Re: Docket 17-3550-INV - Request for Immediate Status Conference

Since that time, however, Intervenors have obtained additional information which confirms that the Addison Natural Gas Pipeline was constructed in a manner that fell below the level of care required by the Commission. The new information again raises the specter that Vermont Gas Systems has placed in jeopardy the safety of the public, the health of Vermont's wetlands and streams, and the integrity of the Commission's permitting process. An independent investigation is needed, as quickly as possible. For example, documents recently provided to us¹ reveal that in 2016-2017 VGS excavated six sites to look for pipeline anomalies. VGS photographed and made notes of what they found. See attached report, 12" ANGP Transmission Pipe Excavation Inspections, June 21, 2018, by VGS's Christopher LeForce. The photographs, reports and field notes from the six excavations show that at two of the six sites VGS blatantly failed to comply with the commitments it made to the Commission:

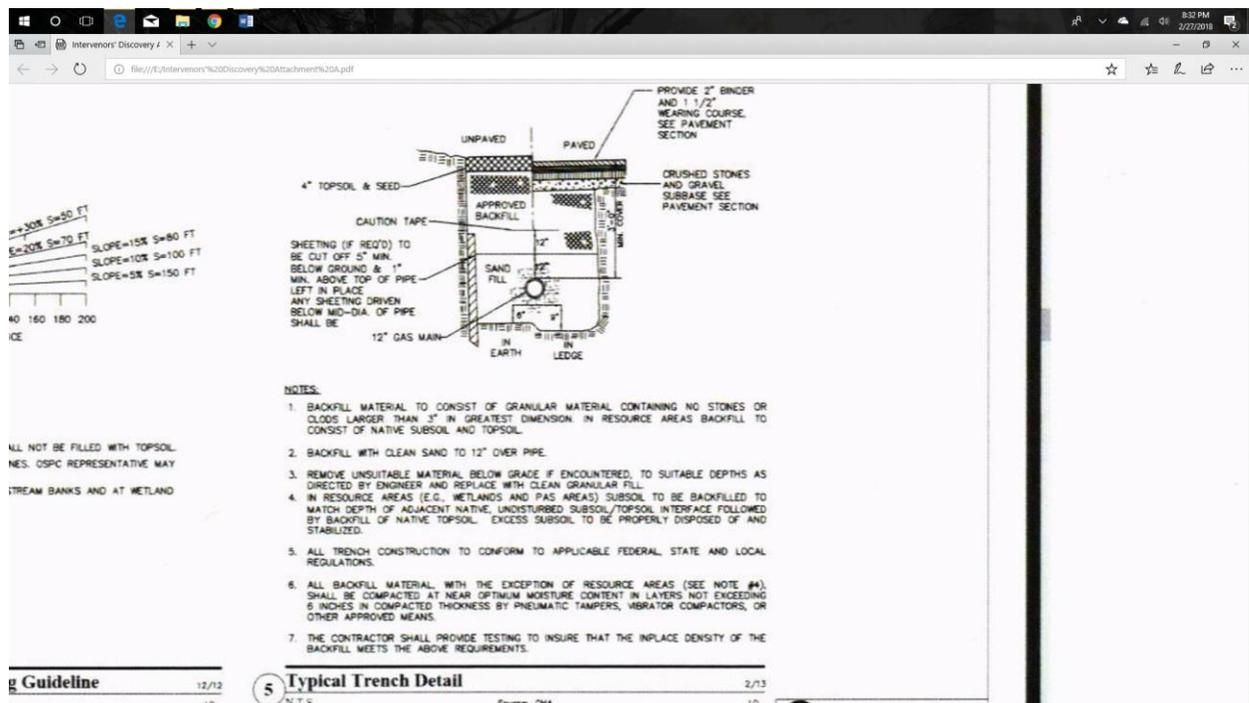
Site #1: Photographs show pipeline enveloped in clay. No sand bedding was used. Notes say that clay and sand were found; however, that no soil samples were collected.

Site #2: Photographs show pipeline in clay with no sand bedding, surrounded by rock fragments as large as half a foot long (in comparison

to the 12” pipeline). Notes in the report say “pipe padded with damp clay like material” and “Backfill was mostly shot rock above the pipe.” The field notes say the soil the pipeline was found in was “Rock.” The field notes also say “padded in clay, buried in shot rock.”
